Emeric Construction Submittal # 0500-1
 This drawing or submittal has been reviewed for compliance with plans and specifications and coordination with the work of others. Approval does not relieve supplier or subcontractor of responsibility for errors, omissions, or non-compliance with the contract documents.
 Approved Approved as noted
 Revise and resubmit
 By: *[Signature]* Date: 1-26-95

FABRICATION PRODUCTS
 6131 NE. 63 rd. Street
 Vancouver, WA 98661
 Phone (360) 696-1324

DRAWN BY	DATE	CUSTOMER	CITY OF McMinnville	CONTRACT NO.
CHECKED BY	DATE	STRUCTURE	McMinnville Comm. Center	DWG NO.

Emerick Construction Submittal # 0500-2
 This drawing or submittal has been reviewed for compliance with plans and specifications and coordination with the work of others. I approved does not relieve supplier or subcontractor of responsibility for errors, omissions, or non-compliance with the contract documents.
 Approved Approved as noted
 Advise and resubmit
 By: [Signature] Date: 2-20-95

CONDITION AT TRUSS TO
WALL BEARING PLATE

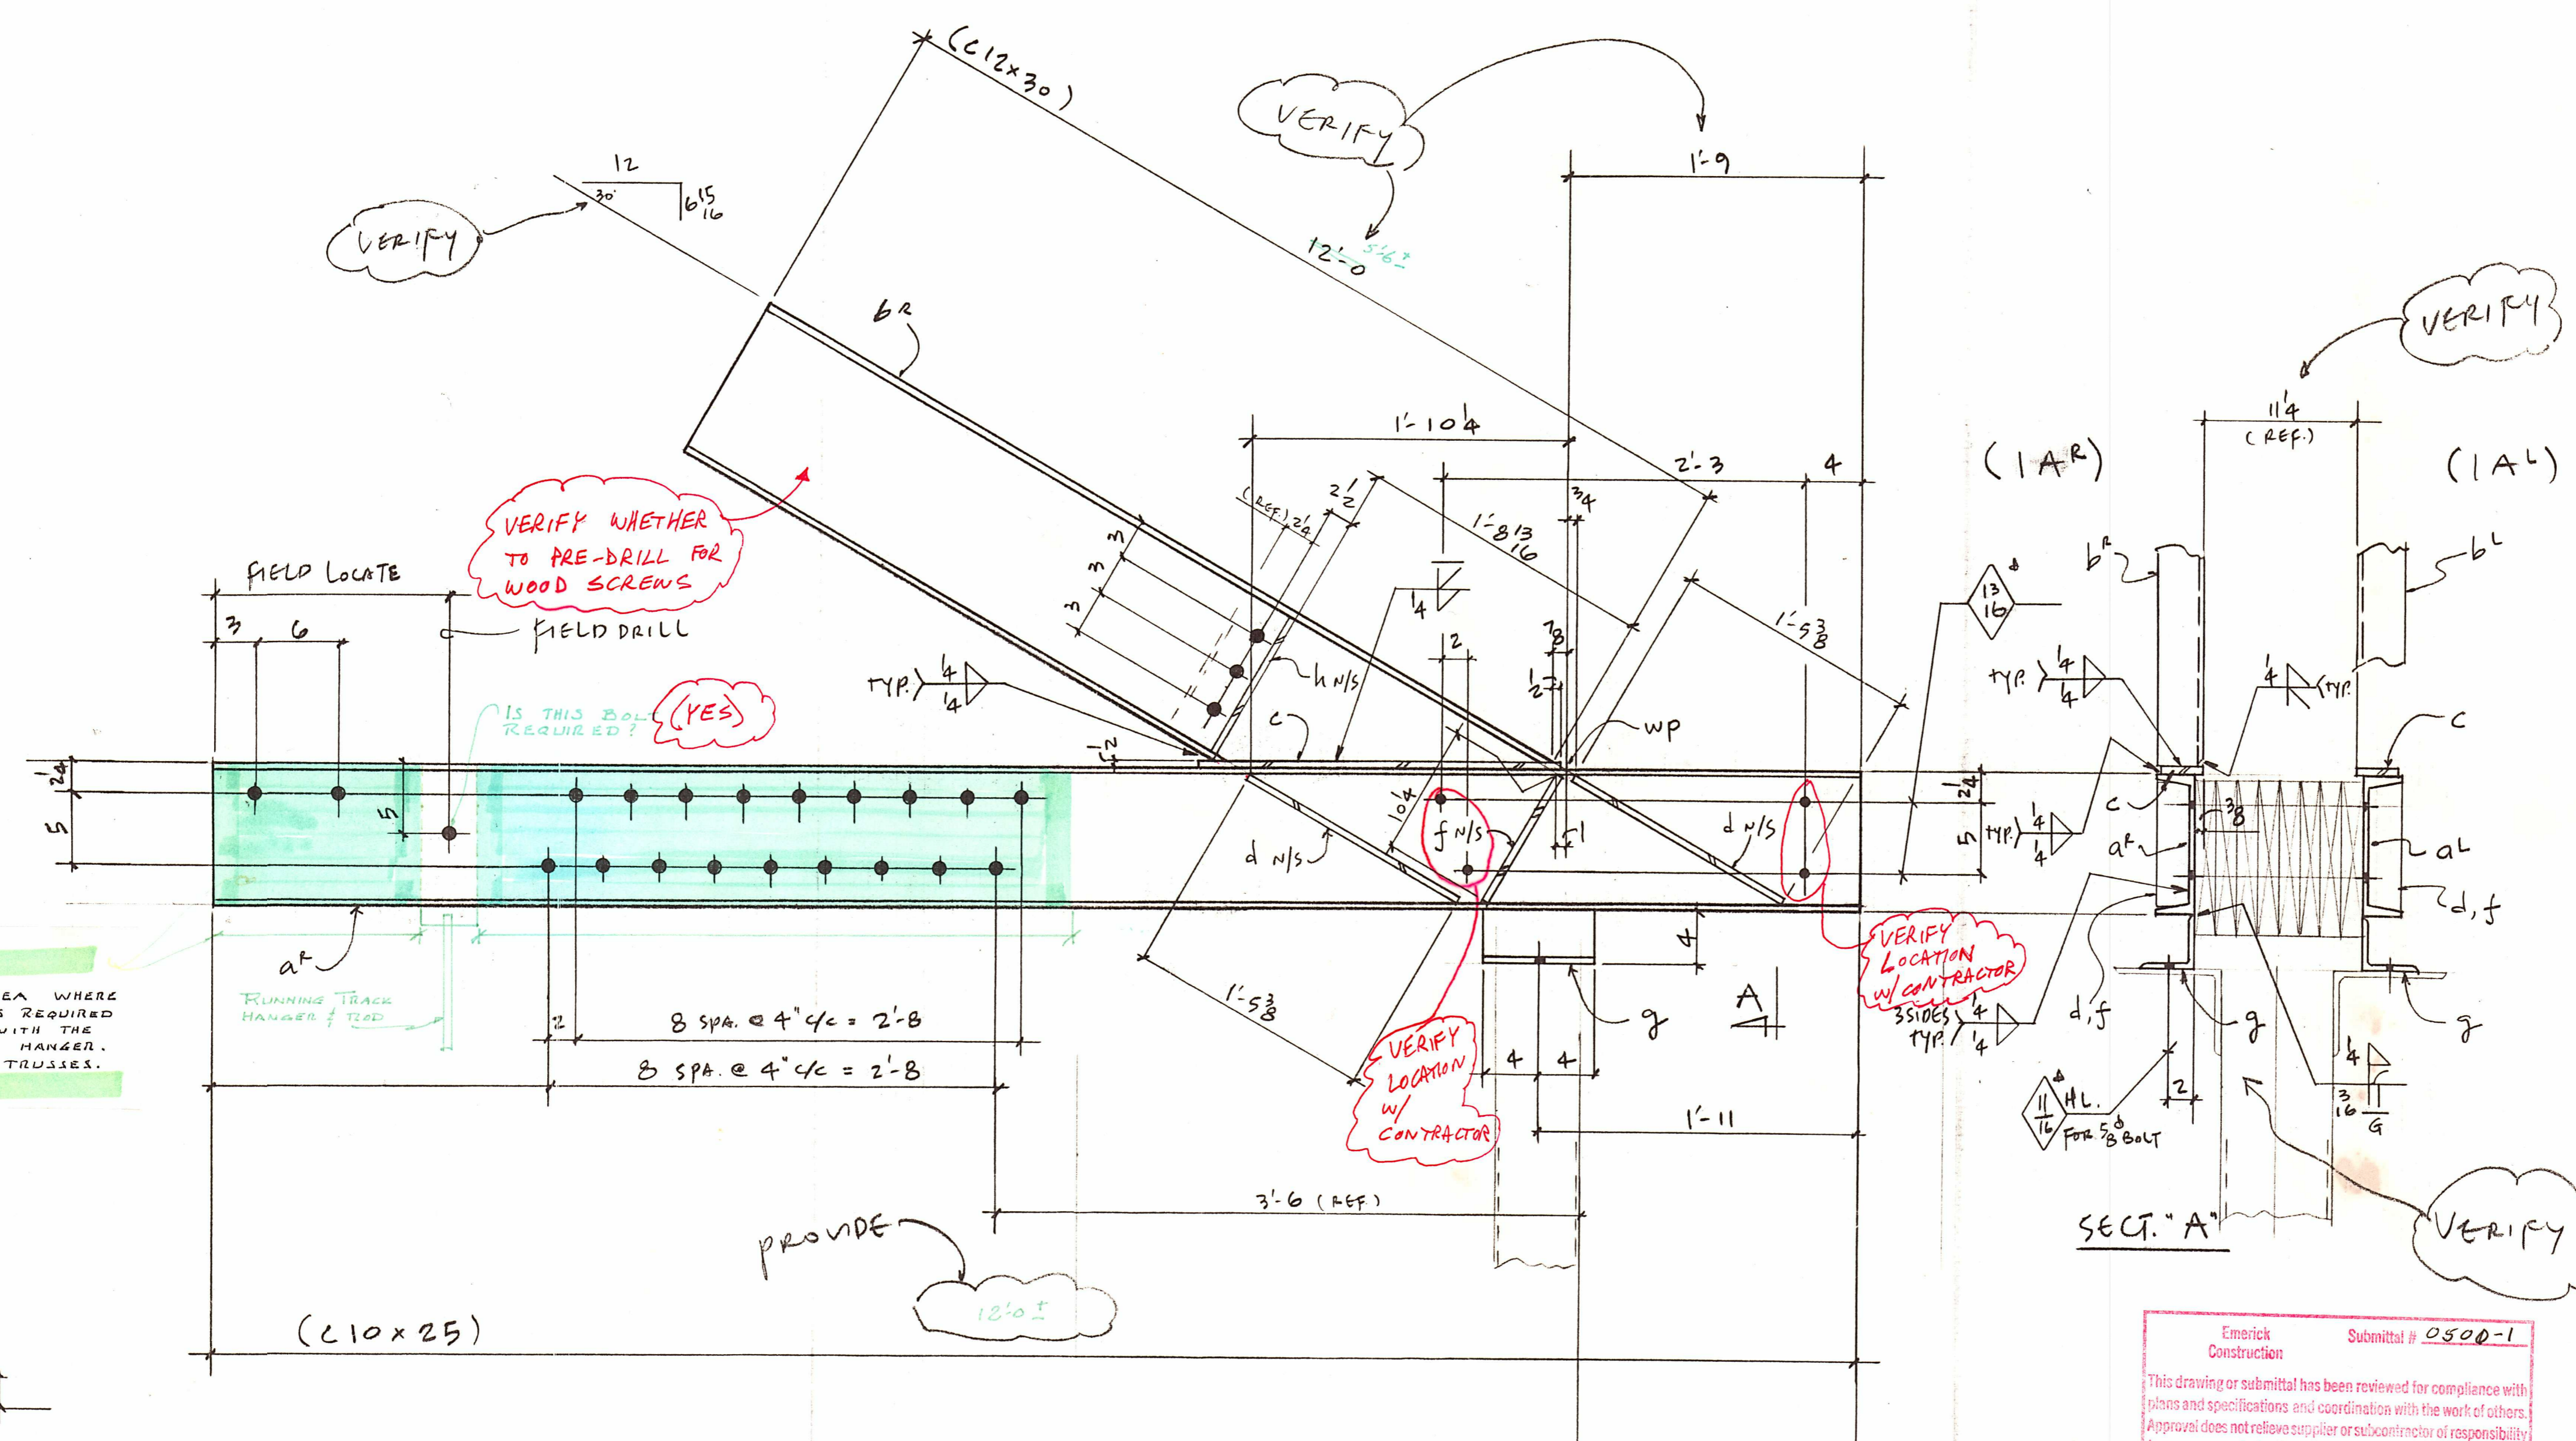
SEE ATTACHED DRAWING FOR EXISTING WALL CONDITIONS. DIMENSIONS VARY FROM TRUSS TO TRUSS.
 THE BOTTOM CHORD CHANNEL WILL BE SHORT AT THE GRID 15 TRUSS DUE TO INTERIOR WALL CONDITIONS.

SECOND FLOOR PLAN
 1/8" = 1'-0"

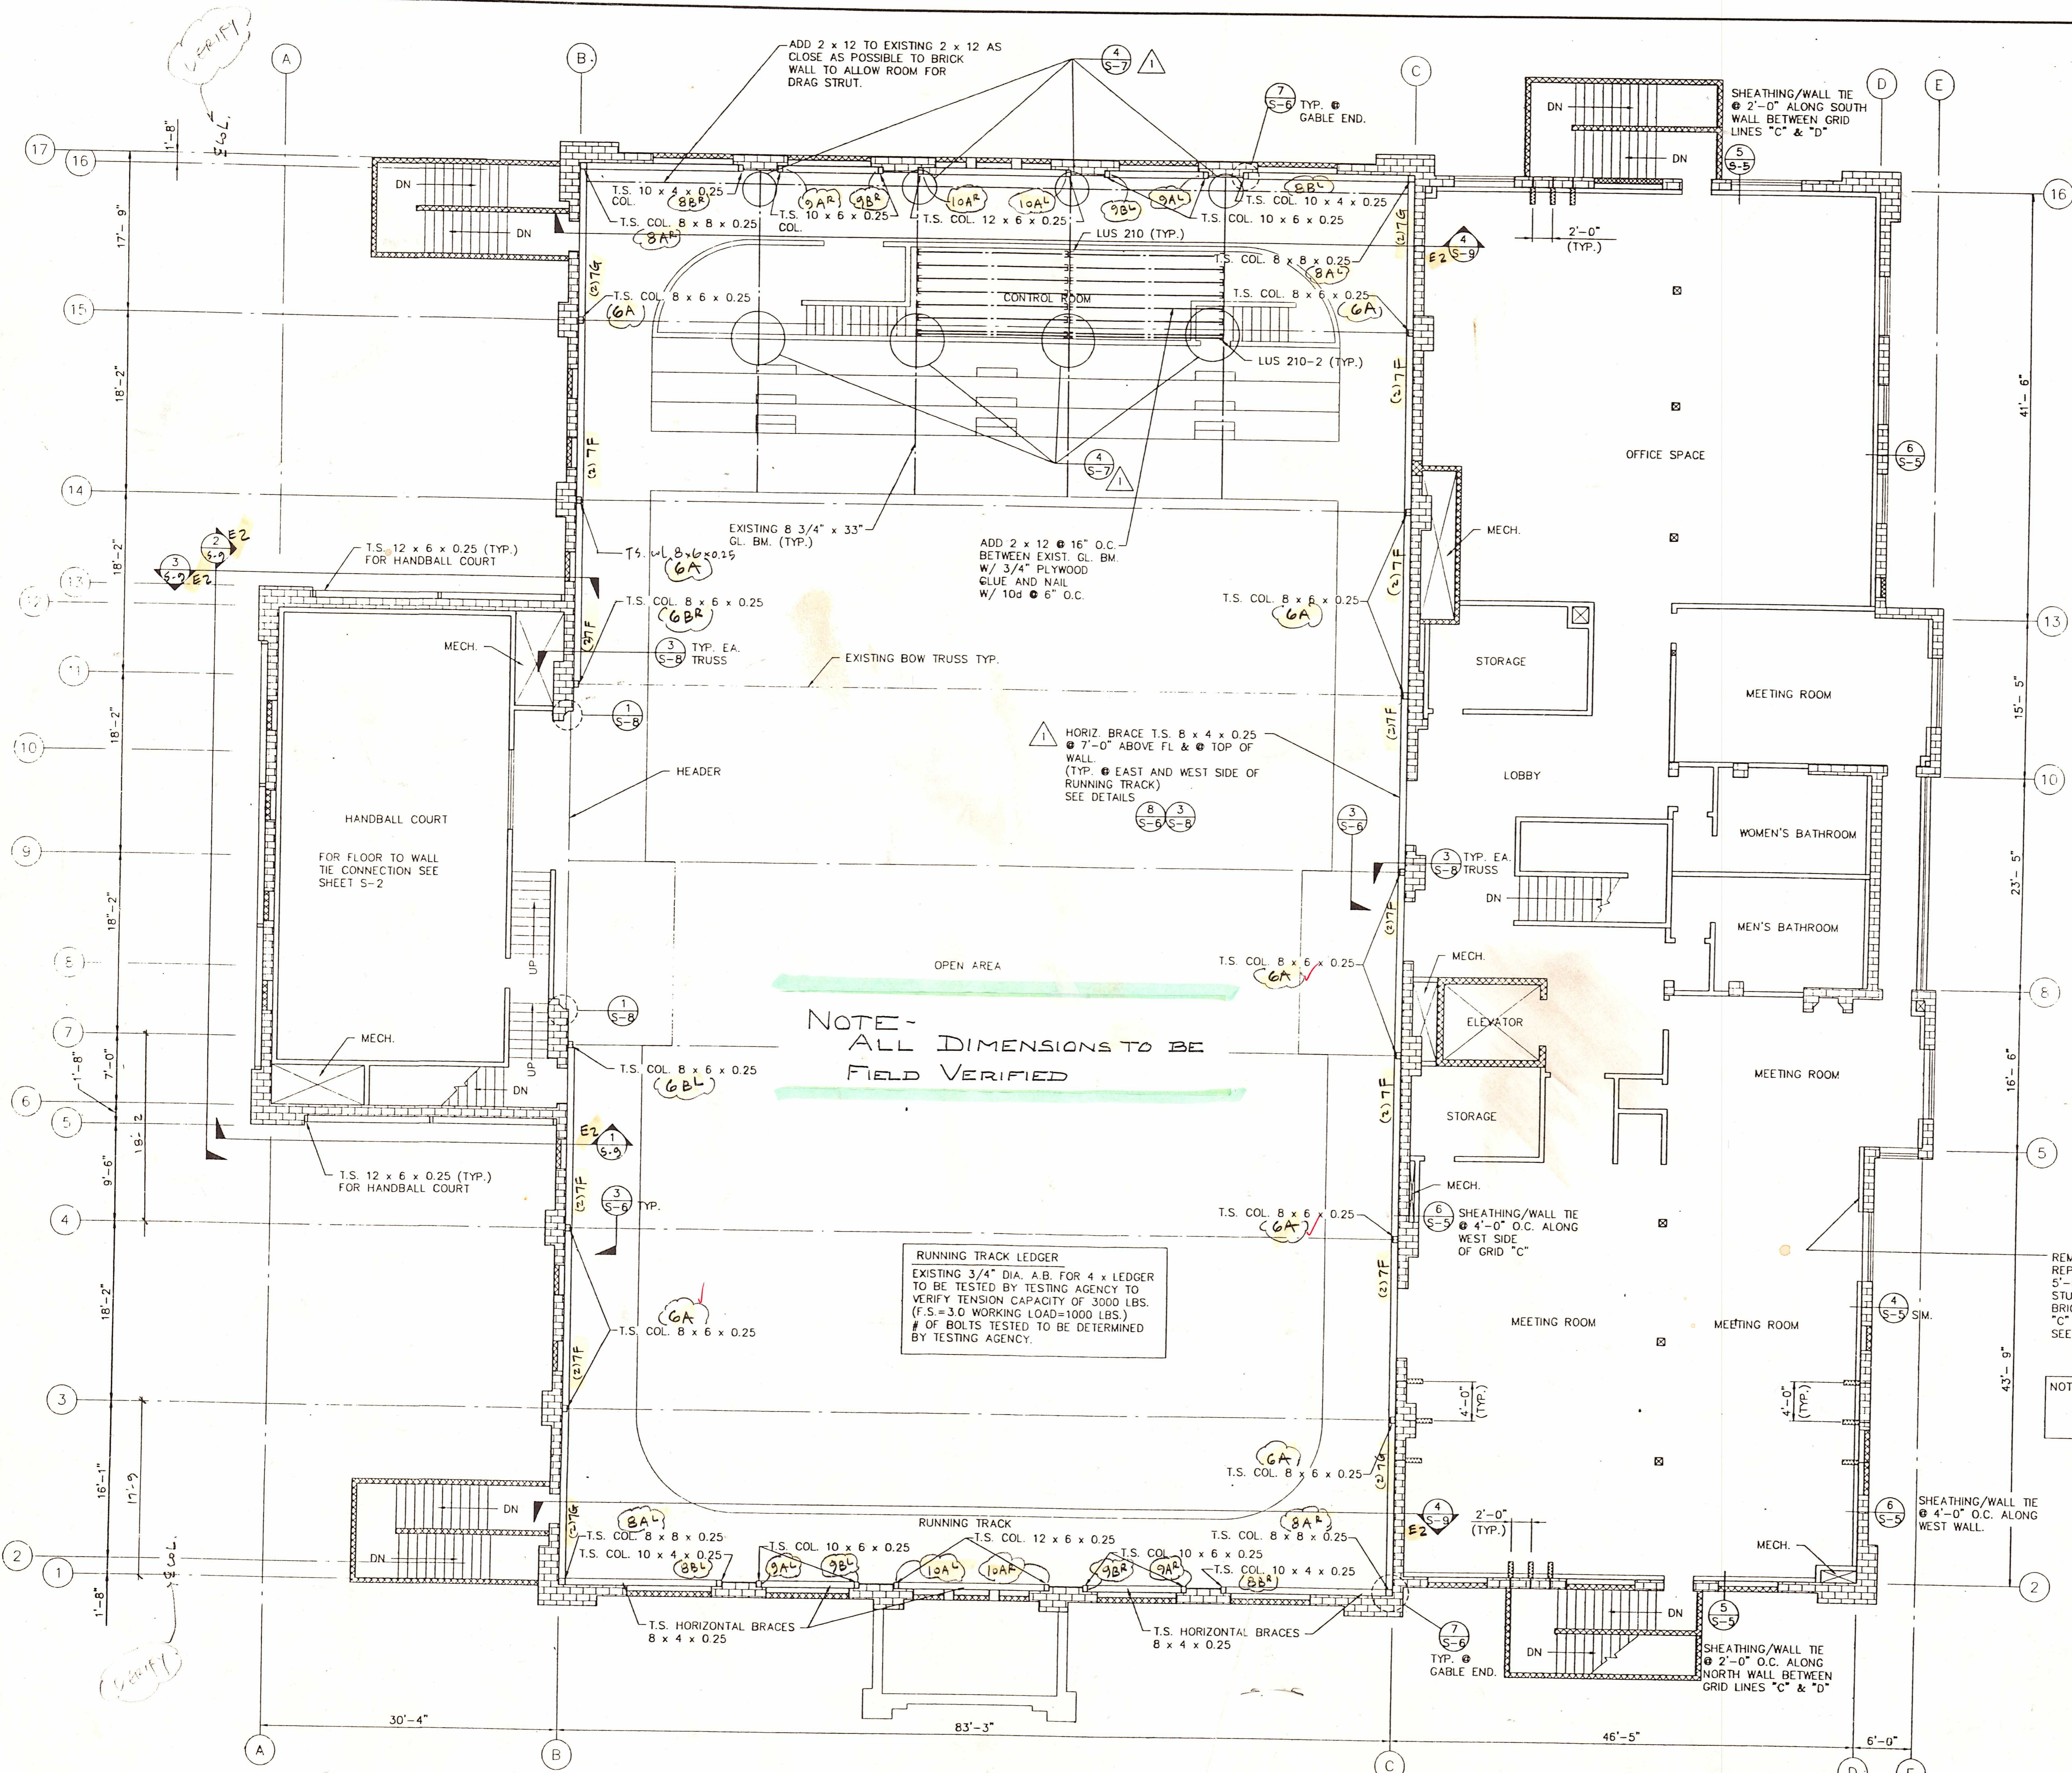
RUNNING TRACK LEDGER
 EXISTING 3/4" DIA. A.B. FOR 4 x LEDGER TO BE TESTED BY TESTING AGENCY TO VERIFY TENSION CAPACITY OF 3000 LBS. (F.S.=3.0 WORKING LOAD=1000 LBS.) # OF BOLTS TESTED TO BE DETERMINED BY TESTING AGENCY.

REMOVE EXISTING GYP. & 2x FURRING, REPLACE W/ 2 x 4 HORIZ. LEDGER @ 5'-6" ABOVE FLOOR AND METAL STUD WALL. TYP. ALL EXTERIOR BRICK WALLS BETWEEN GRID LINES "C" & "E" SEE DETAILS (1) (5) (5-7) (5-7)

NOTE: ADD HORIZ. 2 x 4 LEDGER 6" ABOVE ALL DOORS AND 6" ABOVE AND BELOW ALL WINDOWS.

8 STEEL HORIZ. BRACE SECTION
S-6 3/4" = 1'-0"

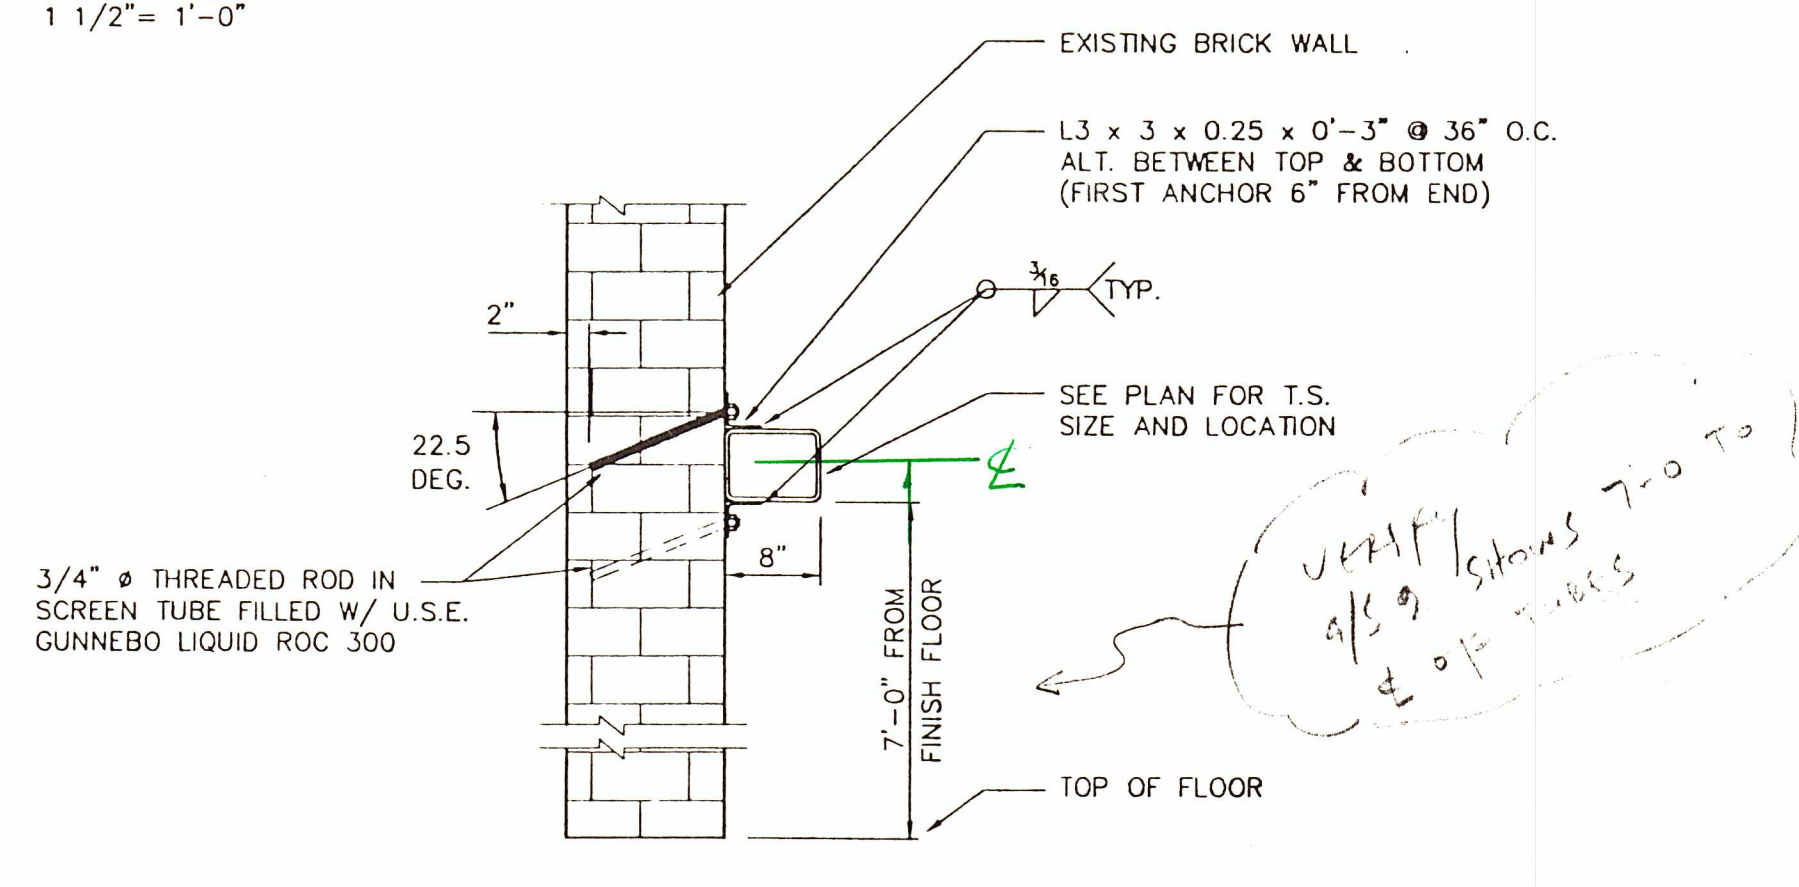
APPROVER PLEASE VERIFY:
1 2 ROWS OF BOLTS AS SHOWN WILL INTERFERE W/ CORNERS OF BRICK WALL OR PILASTER!
2 SHOULD CAP BE SKEWED PER BOWSTRING TRUSSES, & WHAT BEVEL?
YES - FIELD VERIFY SLOPES.

VERIFY SLOPES TO TOP OF TUBES
